## TECHNICAL SERVICE BULLETIN

**Subject:** Obsolescence of dedicated electrical versions of the IDC style agitator/carbonator boards 620314825 (120V) and 620716715 (230V). Both will be replaced with universal 620314825-100 (100V-240V).

**Products affected:** IDC and Spire equipment, in addition to select Enduro (ED175 Renew and Shots) units with agitator/carbonator control boards 620314825, 620314825-100, and 620716715

**Date:** 12/22/2022      **Rev** 2.1

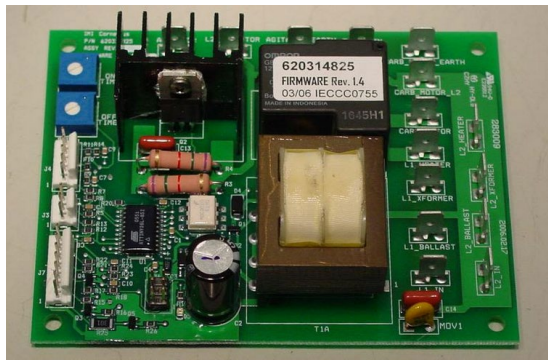
The 620314825-100 iteration of the IDC style agitator/carbonator board includes an interlock circuit previously used for units that had door and/or lid switches. Now that the board will also be used on units that do not utilize the interlock circuit, beginning with 620314825-100 Rev G a jumper will come standard installed in position J9 to short the circuit.

620314825 (120V) or 620716715 (230V) control boards replaced with 620314825-100 (120-240V) will require the jumper to be installed to close the interlock circuit. If the jumper is not installed the ice agitator motor will not operate.

- For ED 175 (Renew and Shots) units, the jumper must be removed and the harness that was plugged into J9 of the board being replaced and plugged into the new board. Failure to do so will result in the rotary ice gate solenoid not operating.
- For IDC units, if the jumper is removed and the harness that was plugged into J9 is reconnected, the lid and door interlocks will function. If the jumper is left plugged in, the unit will operate normally however lid and door interlocks will not function. If nothing is plugged into J9 the agitator motor will not operate.

If the 620314825-100 control board is Rev F or prior, jumper 620062577 must be purchased and installed separately if the unit does not have a lid/door interlock switch.

To maintain proper functionality when replacing a carbonator/agitator control board care must be taken to note if the interlock circuit needs to be jumped out at position J9 or if the lid/door interlock switch harness should be plugged in.
